Access Compliance Report

Public Rights-of-Way

(Curb Ramps)

Intersection ID: 10849	Main Street: FREEDOM_DR	Cross Street: PACIFIC_ST	Location: NW
ADA ID: 46ECFE39475D	Ramp Type: Perp	Initial Pass/Fail: Fail	Overall Compliance: No
		Severity Score: 8.75	
Codes/Mitigation Info/Possible Solution		Field Measurements/Component Compliance

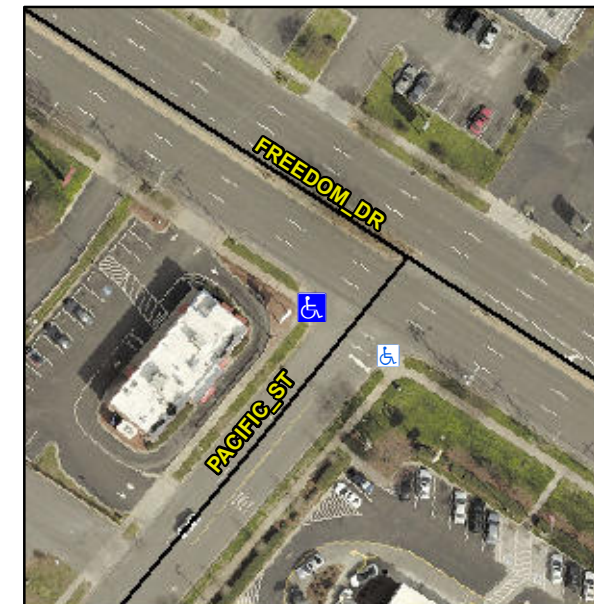
PROW/ADA:

Not Found, R304.5.1

Compliance	Description	Data	Compliance	Description	Data
N/A	Ramp Length (in)	53.0	Yes	Ramp Slope (%)	6.0
No	Ramp Width (in)	47.0	Yes	Ramp XSlope (%)	0.6
N/A	Flare Type LT	N/A	N/A	Flare Type RT	N/A
N/A	Flare Slope LT (%)	N/A	N/A	Flare Slope RT (%)	N/A
N/A	Flare Traversable LT?	N/A	N/A	Flare Traversable RT?	N/A
N/A	Landing Length (in)	N/A	N/A	DWS Provided?	N/A
N/A	Landing Width (in)	N/A	N/A	DWS Contrast?	N/A
N/A	Landing Slope (%)	N/A	N/A	DWS Length (in)	N/A
N/A	Landing X Slope (%)	N/A	N/A	DWS Full Width?	N/A
N/A	Landing Curb? (Y/N)	N/A	N/A	DWS Offset (in)	N/A
N/A	Shared Landing?	N/A			
N/A	Gutter Ponding?	N/A	N/A	Gutter Slope (%)	N/A
N/A	Gutter Lip Ht (in)	N/A	N/A	Gutter X Slope (%)	N/A
N/A	Painted X Walk1?	Yes	N/A	Painted X Walk2?	N/A
	X Walk 1 Direction	To SE		X Walk 2 Direction	N/A
N/A	X Walk 1 Width (in)	93.0	N/A	X Walk 2 Width (in)	N/A
	X Walk 1 Slope (%)	1.4		X Walk 2 Slope (%)	N/A
	X Walk 1 X Slope (%)	0.2		X Walk 2 X Slope (%)	N/A

Possible Solutions:

Remove & Replace Entire Ramp.
